Central Coast Quarter 26 Mann Street Gosford

RTS RESPONSE PACK

26-32 MANN STREET, GOSFORD

Level 3 (Mann Street)

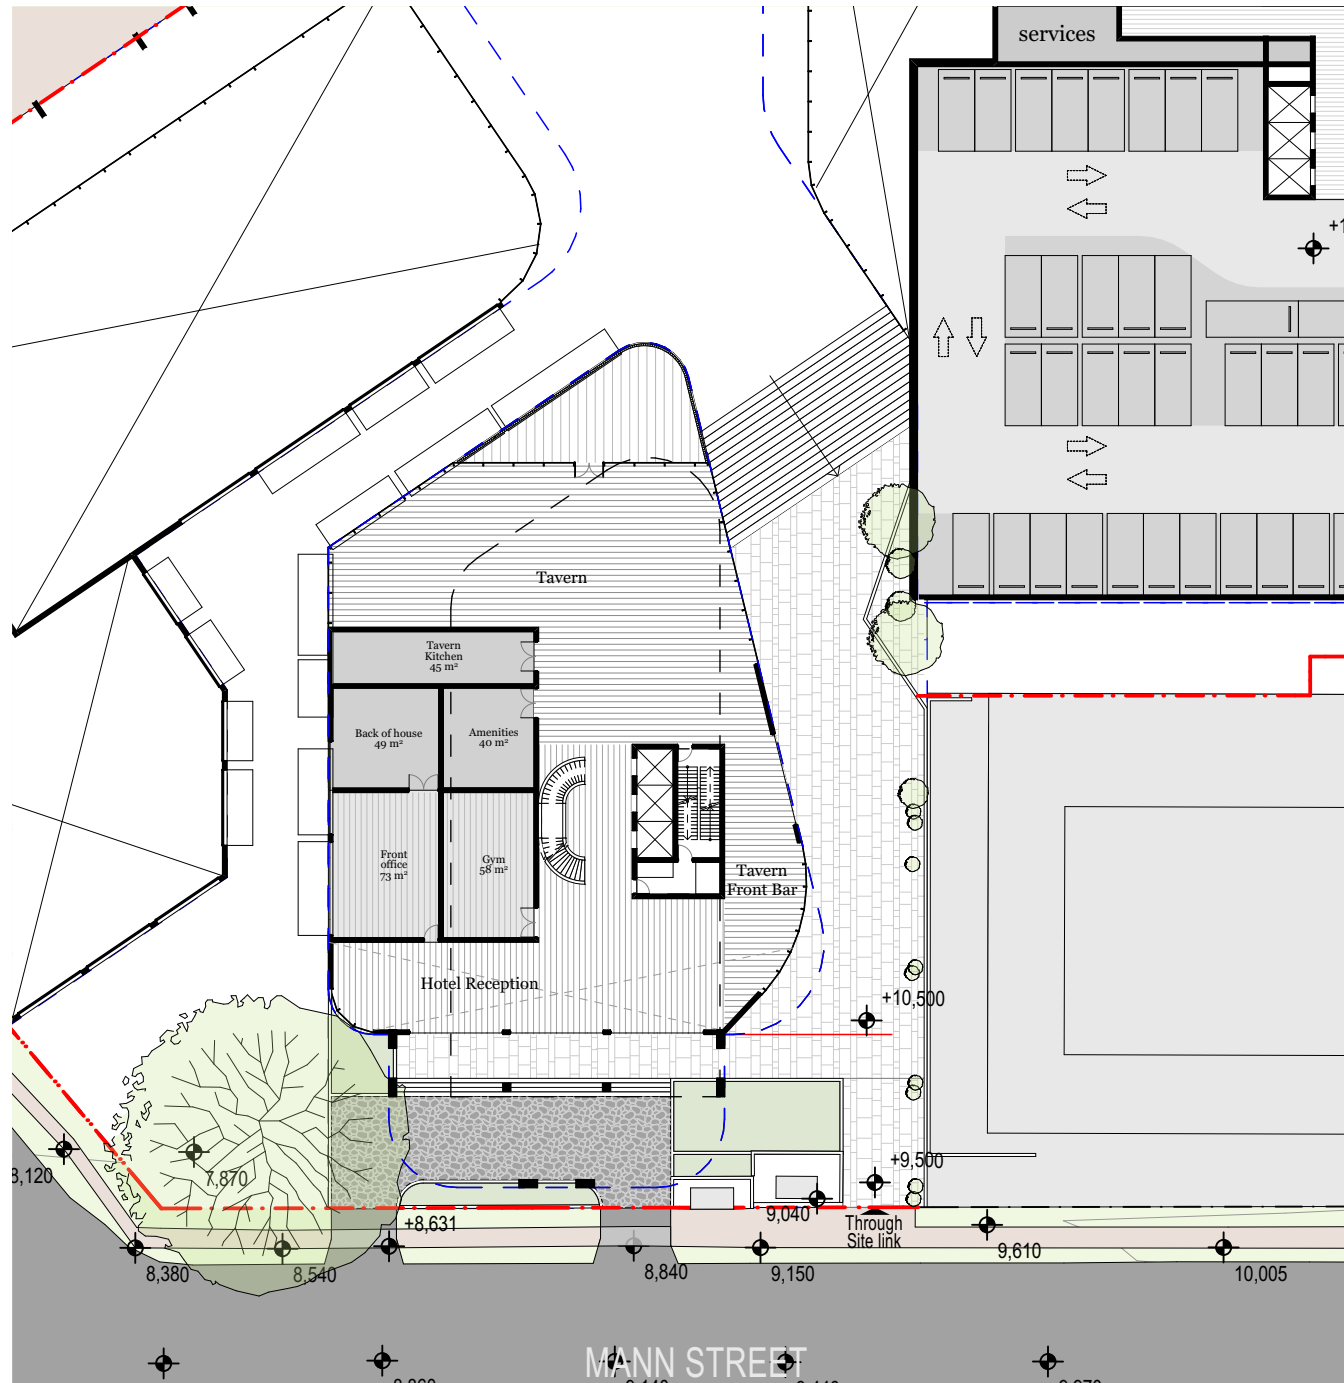
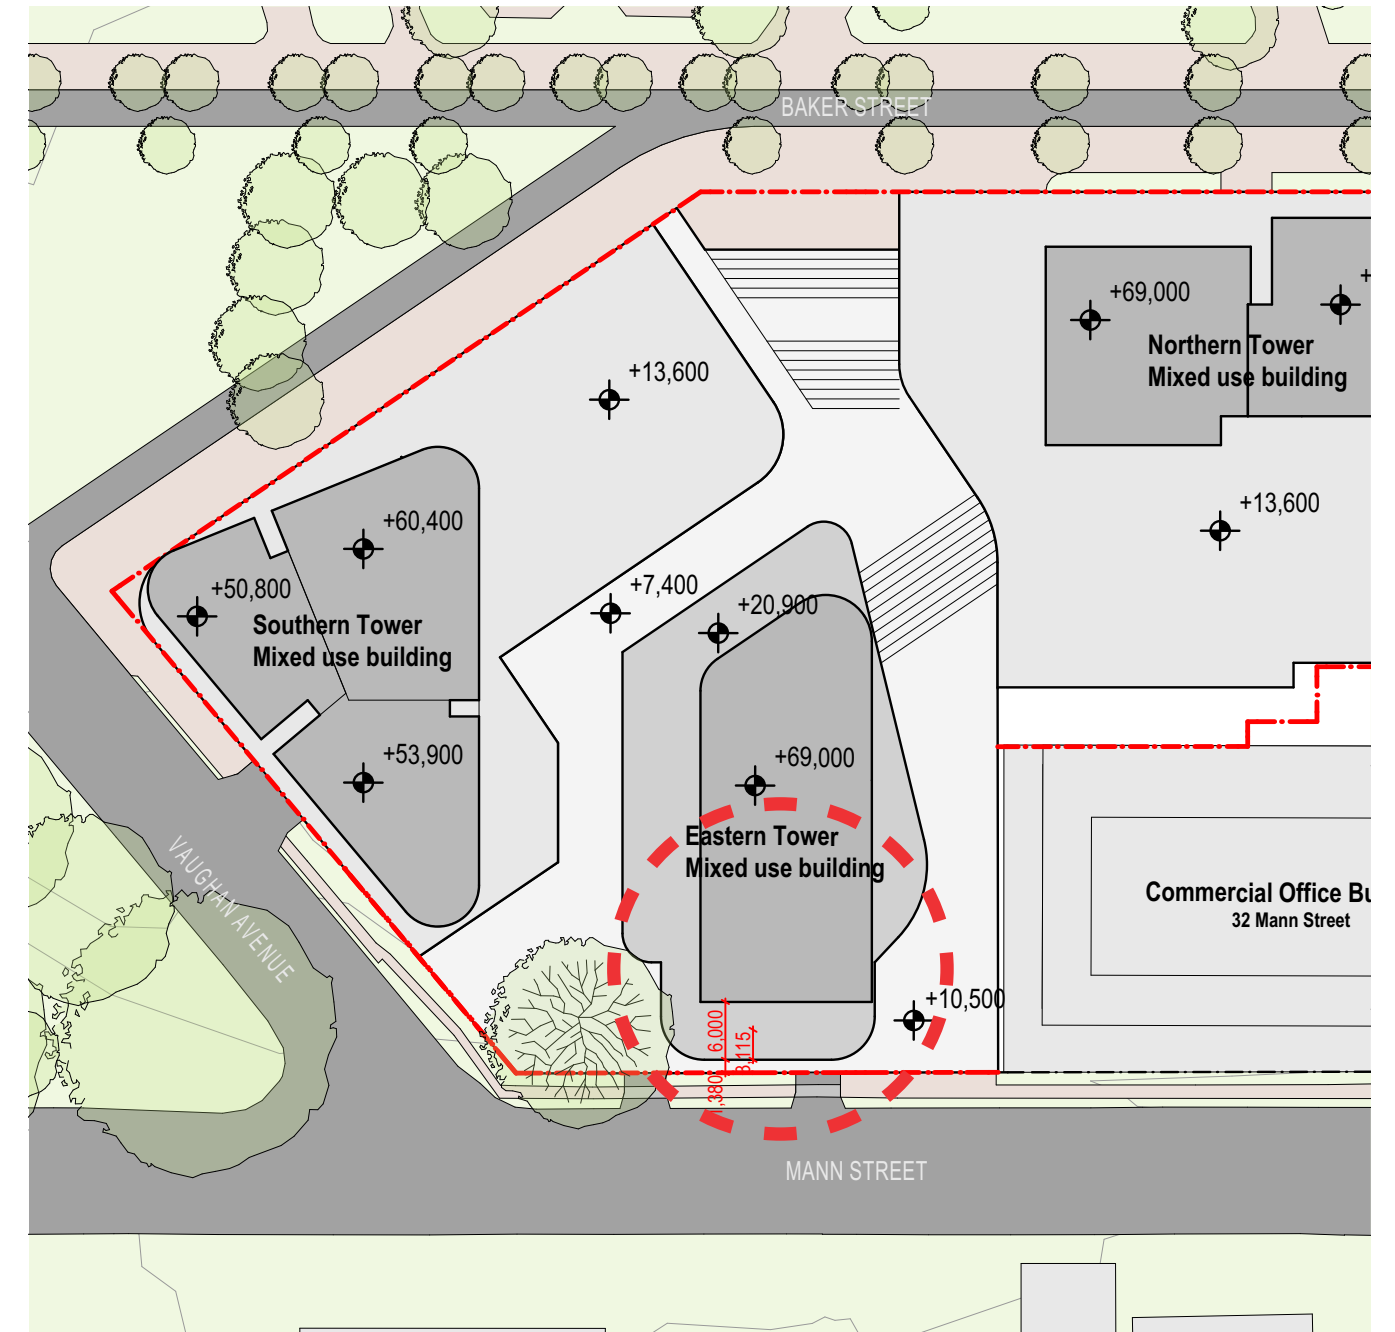
- 4) Providing additional vertical articulation in all the buildings, to reduce the perceived bulk and scale of the buildings when viewed from key vantage points (this may be specified in the design guidelines above).
- 5) Relocating the Eastern Tower envelope to increase the setback from the podium street wall to respect the scale of Mann Street.
- 6) Increasing the width of the northern through site link to provide greater amenity for the site's public domain.

Eastern tower envelope has been revised to increase setback from the podium wall to 6m. Podium footprint has been revised to increase the width of northern through site link for increased amenity to the public domain.
